Wisconsin Department of Transportation

Proposal #09: 2350-00-70, WISC 2018 087
Hamilton St/Douglas Av, C of Racine
Main Street to Goold Street
STH 32
Racine County

This is Addendum No. 01, which provides for the following:

Addendum No. 01
 ID 2350-00-70
 Revised Sheet 192
 February 2, 2018

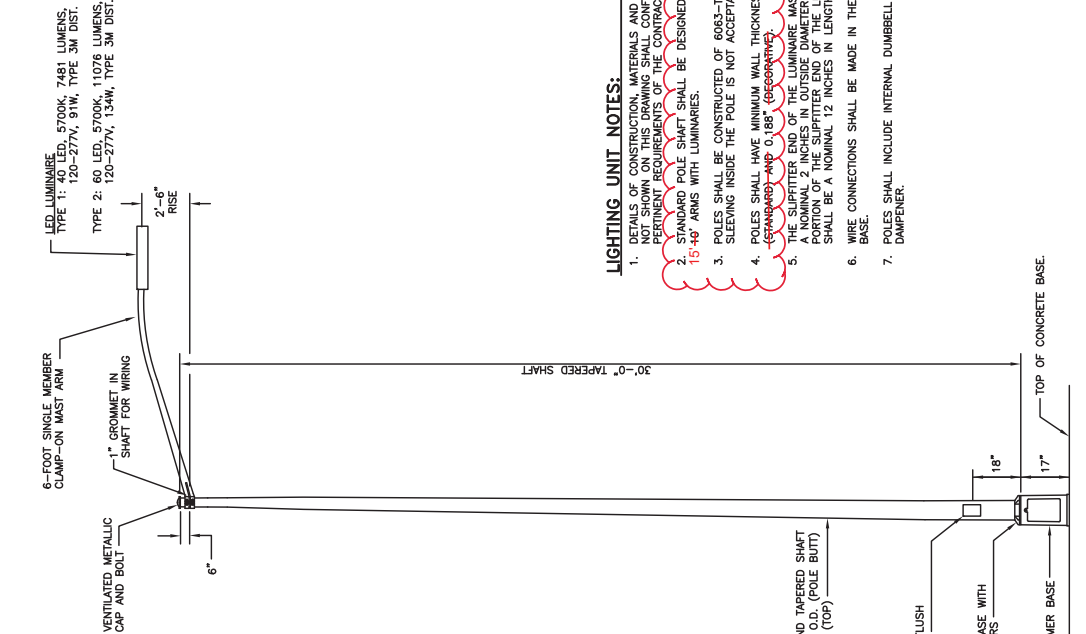
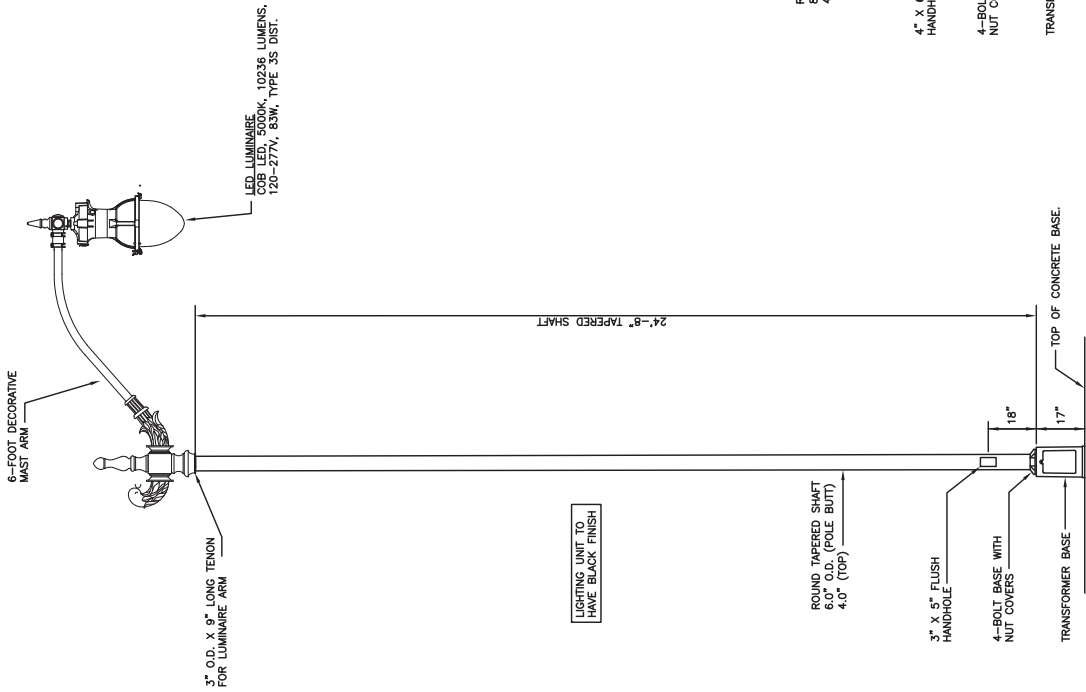
| Revised Plan Sheets | |
|---------------------|--|
| 192 | Electrical Details (Revised notes that conflict with SDD) |

- DETAILS OF CONSTRUCTION, MATERIALS AND WORKMANSHIP SHALL BE IN ACCORDANCE WITH THE REQUIREMENTS OF THE CONTRACT.
1. STANDARD POLE SHAFT SHALL BE DESIGNED TO INCLUDE TWIN 1/2\"/>
 2. POLES SHALL BE CONSTRUCTED OF 6063-T6 ALUMINUM ALLOY. SLEEVING INSIDE THE POLE IS NOT ACCEPTABLE.
 3. POLES SHALL HAVE MINIMUM WALL THICKNESS OF 0.156\"/>
 4. THE SLIPFITTER END OF THE LUMINAIRE MAST ARM SHALL BE ANCHORED TO THE SLIPFITTER END OF THE LUMINAIRE ARM. THE PORTION OF THE SLIPFITTER END OF THE LUMINAIRE ARM SHALL BE A NOMINAL 12 INCHES IN LENGTH.
 5. WIRE CONNECTIONS SHALL BE MADE IN THE TRANSFORMER BASE.
 6. POLES SHALL INCLUDE INTERNAL DUMBBELL STYLE VIBRATION DAMPENER.
